NORTHERN BEACHES LOCAL PLANNING PANEL

WEDNESDAY 2 NOVEMBER 2022

4.1 DA2022/0153 - 8 Maxwell Street, Mona Vale - Demolition works and
Construction of a dual occupancy.5

D9.6 Front building line

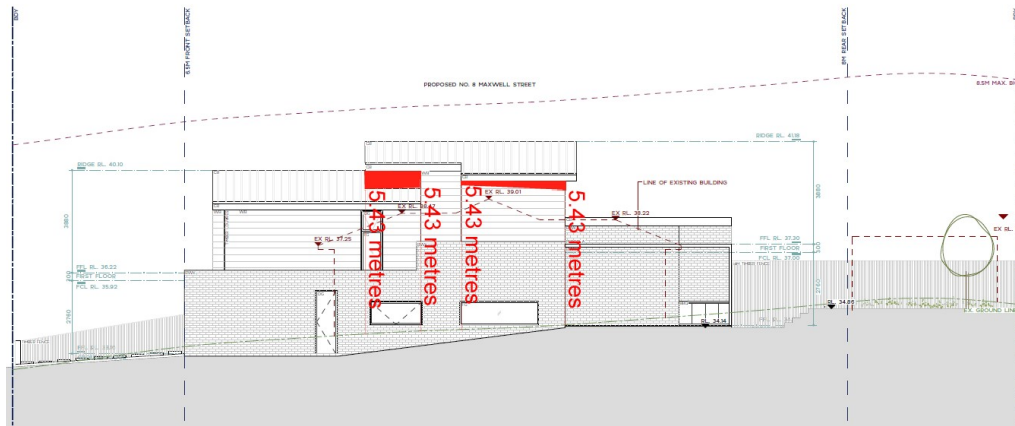
Although it is not marked on the plans, the traffic report suggests a tandem parking situation could be provided for the site.

This is not supported due to the non-compliance with the control and objectives for front building line. In particular, the parking would have an unreasonable visual impact on the street (given the street context).

Figure 1: Elements of the proposal that exceed the 8.5m height plane

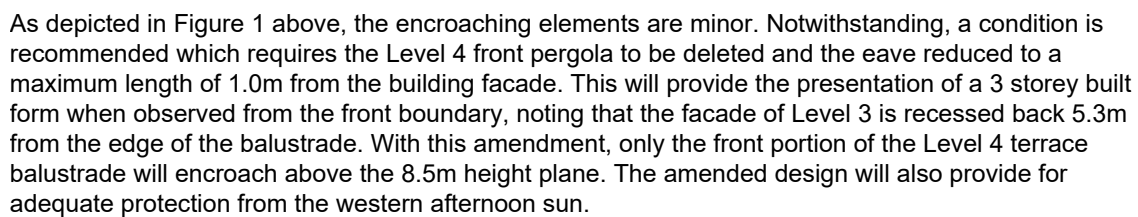
The elements of the proposed dwelling that exceed the 8.5m height plane relate to the Level 4 pergola over the front terrace and Level 4 terrace balustrade, as depicted in Figure 1 below.

The proposed development, as modified via condition (i.e. deletion of upper level pergola), will be similar to the approved dwelling house at 243 McCarrs Creek Road by virtue of the overall building height, level of excavation and terraced floor plate.

Figure 2: Approved dwelling house at 243 McCarrs Creek Road

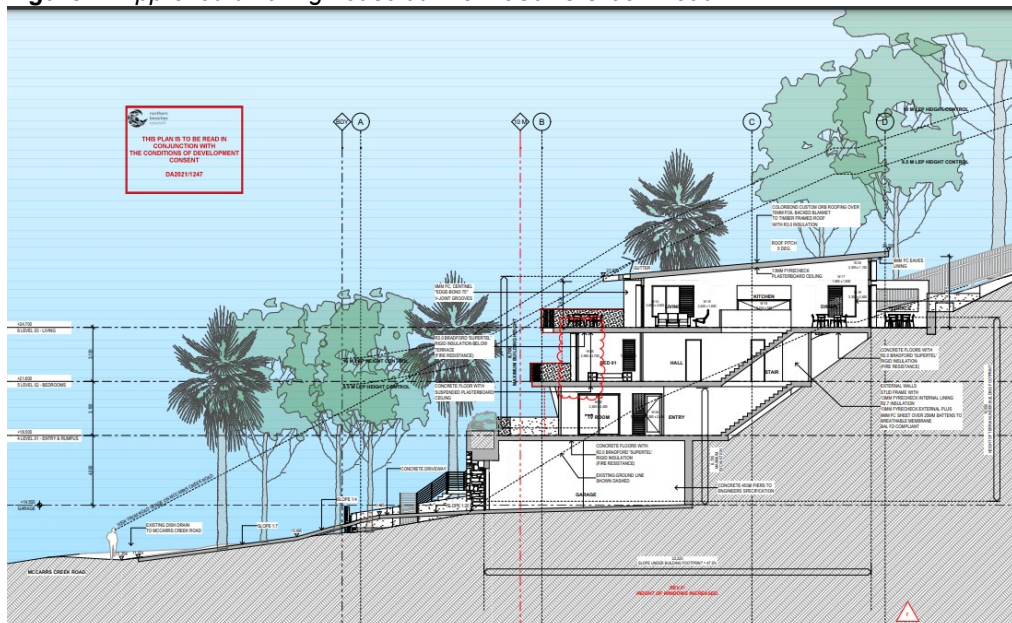
The overall height, bulk and scale of the proposed dwelling house is comparable with the recently approved 4 storey dwelling house on the southern adjacent site (243 McCarrs Creek Road). Each level of the proposal has been terraced to ensure the floor plates correspond with the recently approved dwelling on the adjacent property. Figure 2 below illustrates the floor plates of the approved dwelling house on the adjacent property.

Figure 3: Elements of the building that protrude outside of the standard envelope (outlined in red lines)

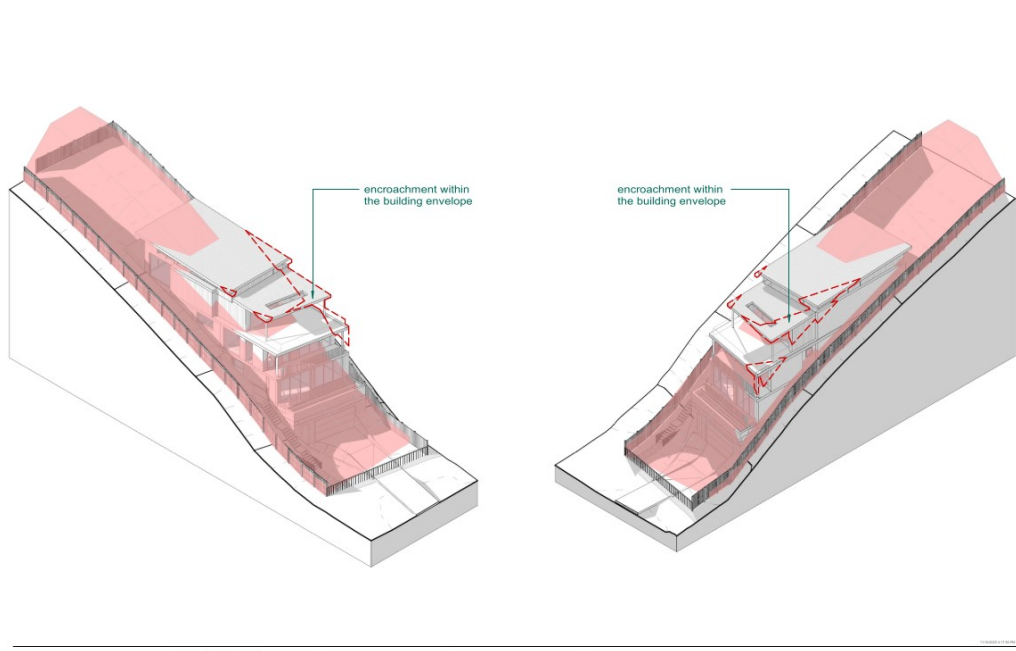
The slope of the land under the proposed building footprint has a 45.95% grade. As the slope of the land under the building footprint is greater than 30%, the proposed development is subject to a merit assessment when applying the envelope control.

The standard envelope applied to sites with slopes less than 30% is determined by projecting planes at 45 degrees from a height of 3.5m above the existing ground level at side boundaries. The proposal protrudes outside of the standard envelope requirement that is applied for sites with slopes less than 30%, as depicted in Figure 3 below.

When considering the development on its merits, it is concluded that the outcomes of the control are achieved. A detailed assessment against the outcomes is provided below as follows:

Figure 1: new building elements that encroach above the 8.5m height plane

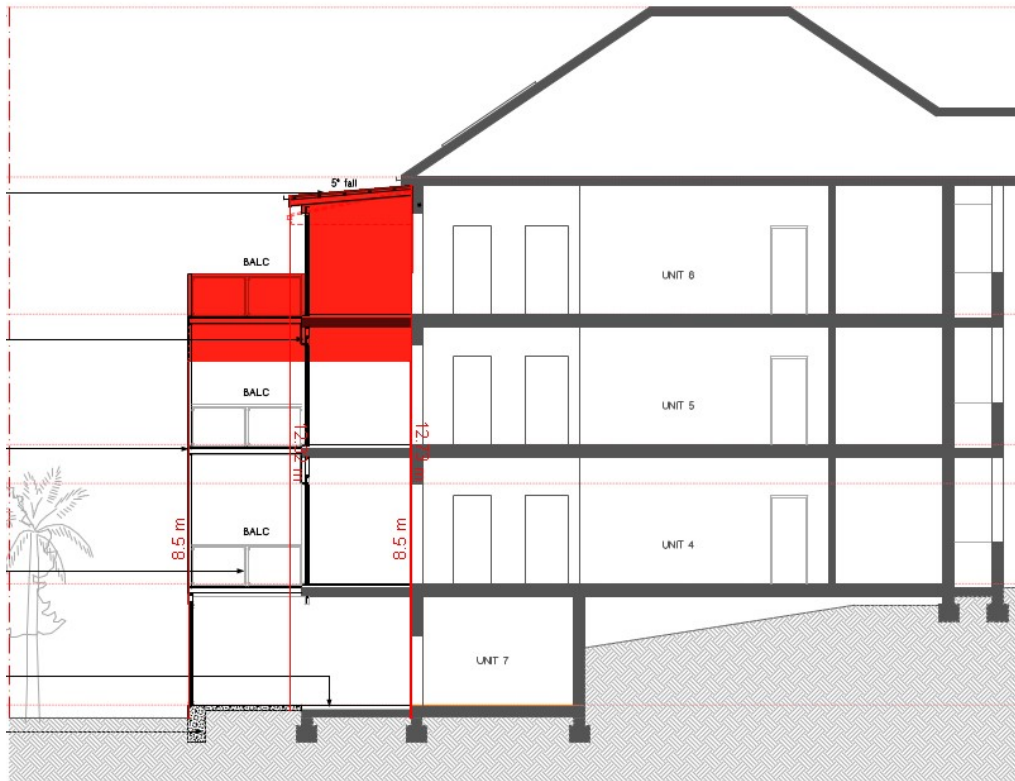
It is important to note that the existing residential flat building encroaches above the 8.5m height plane and that the top of the colourbond roof sheeting located above the upper floor rear facing balcony is located 4.25m below the ridge level of the existing building. The top of the ridge level of the existing building measures at 15.08m above the existing ground level. Hence, the development does not exacerbate the existing height non-compliance.

Figure 1 below depicts the new building elements that encroach above the 8.5m height plane.

Figure 2: additional GFA proposed on the subject site

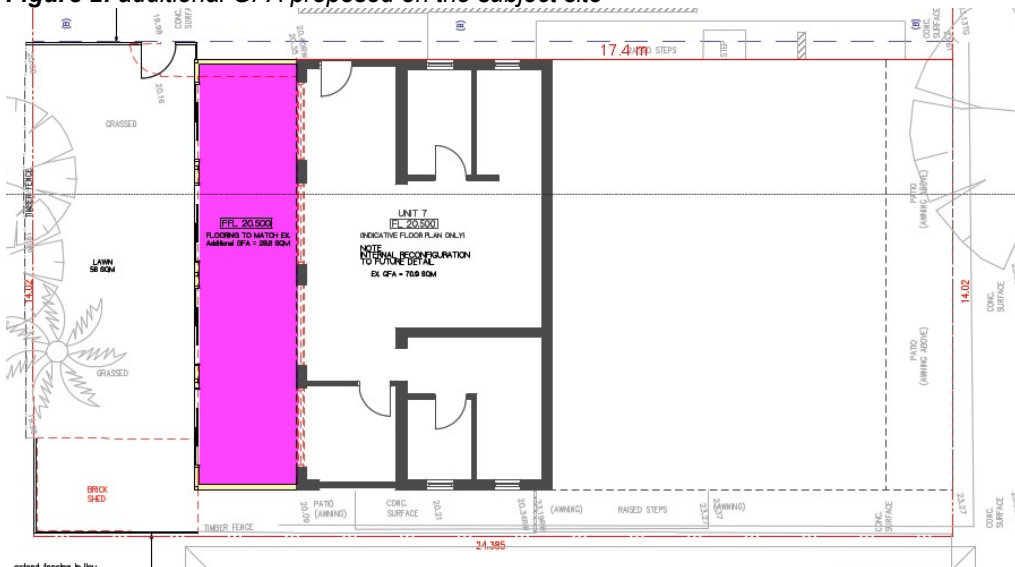
Clause 4.4 of Manly LEP 2013 limits the floor space ratio (FSR) on the subject site to 0.6:1 (205.08sqm). The existing residential flat building significantly breaches this requirement and has a FSR of 1.55:1 (529sqm). The proposed development encloses an existing alfresco area (i.e. existing private open space for Unit 7) to provide additional floor space to Unit 7. This provides for an additional 28.6sqm of gross floor area, thereby increasing the FSR on the site from 1.55:1 to 1.63:1.

Figure 2 below depicts the additional gross floor area that is proposed on the site.
